SEWAGE DISPOSAL SYSTEM

DEPARTMENT OF HEALTH AND MENTAL HYGIENE

A REPAIR

RE: Septic Repair Permit
Former Schultz Property
6566 Hanover Road

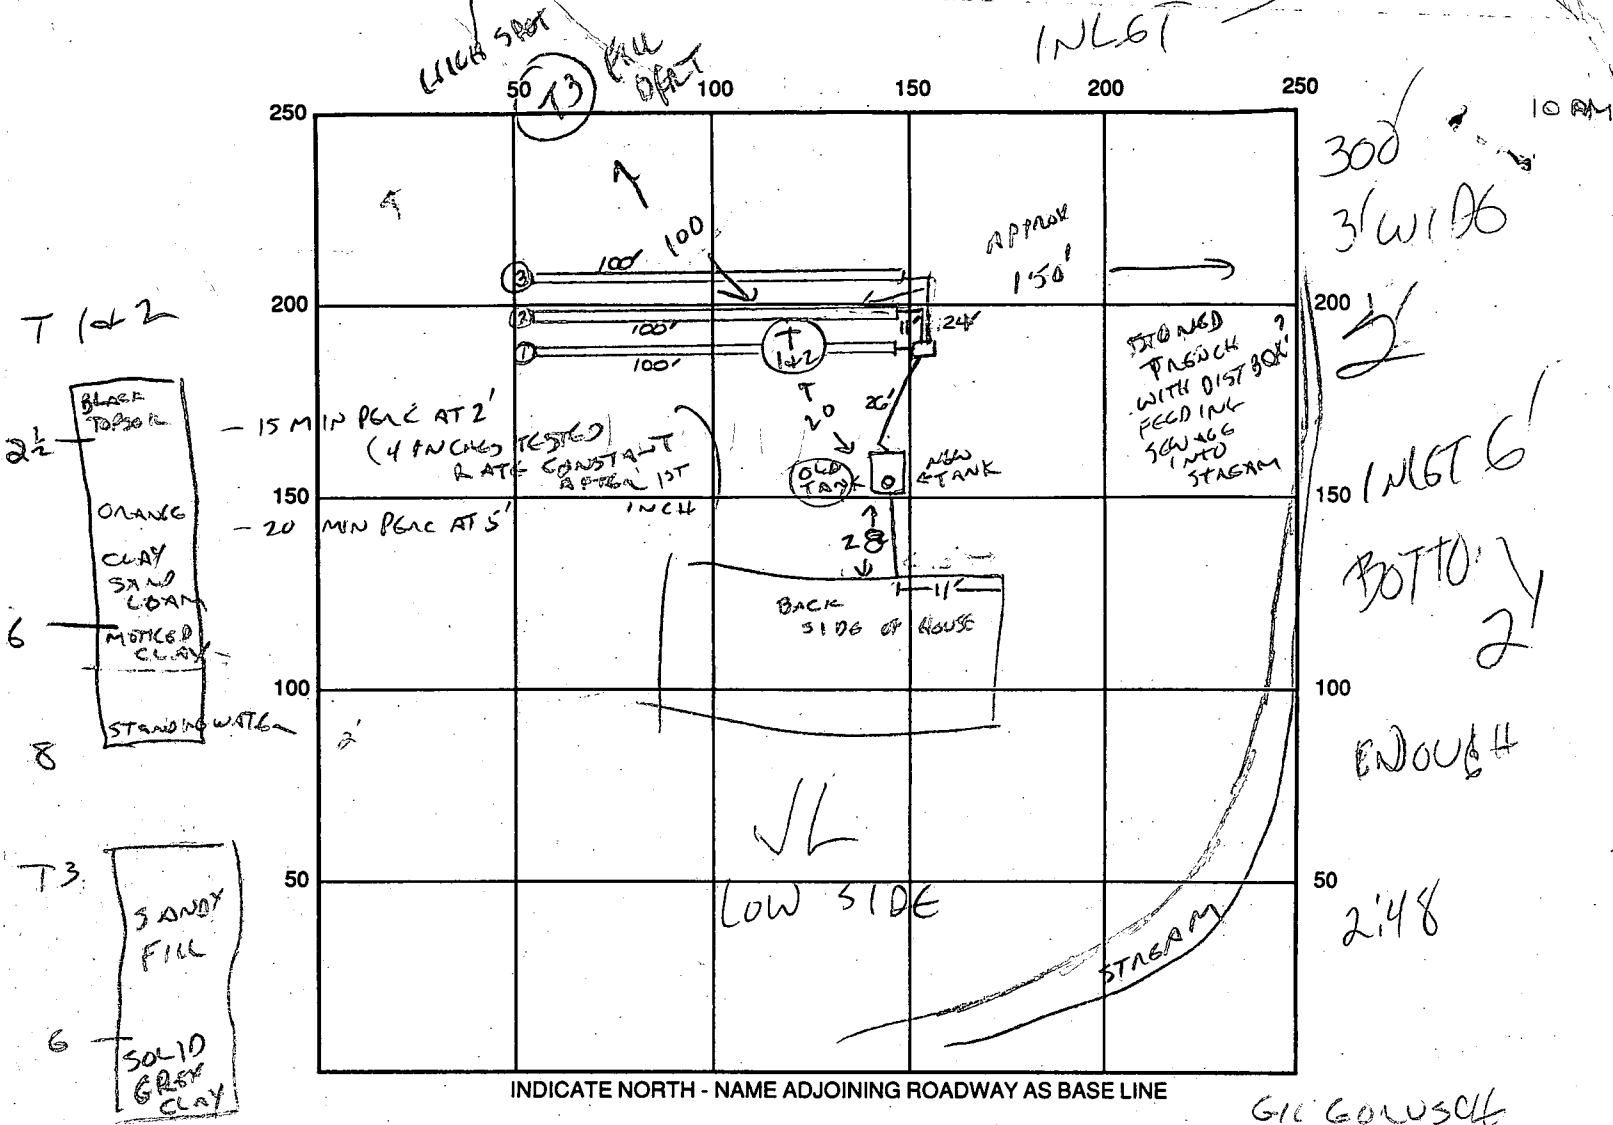
REPAIR - PURPOSE - TO REPLACE DAMAGED DRYWELL AND TO ESTABLISH 10,000 SQUARE FEET EASEMENT IF REASONABLE, POTENTIAL SUBDIVISION INVOLVED. PUBLIC SEWER NOT REASONABLE, ACROSS STREAM.

15 MIN. PERC RATE AT 2' AND 4'. MAXIMUM GROUNDWATER LEVEL JUDGED TO BE 6'.

INSTALL NEW 1500 GAL TANK AND 3 - 100' TRENCHES, INLET 6", MAX BOTTOM DEPTH 24".
TRENCH WIDTH - 3', WILL NEED ADDITIONAL SOIL TO COVER.

COVER NO WORK UNTIL INSPECTED AND APPROVED WILL NEED TO CHANGE PLUMBING TO FIRST FLOOR SERVICE ONLY

REMARKS: OUTLET TO TANK 7' DEEP

10/25/94 OK TO COVER - need to abandon old s.t. and complete house connection. DKS

10/26/94 HOUSE CONNECTION COMPLETE - OK TO COVER ALL (CW)
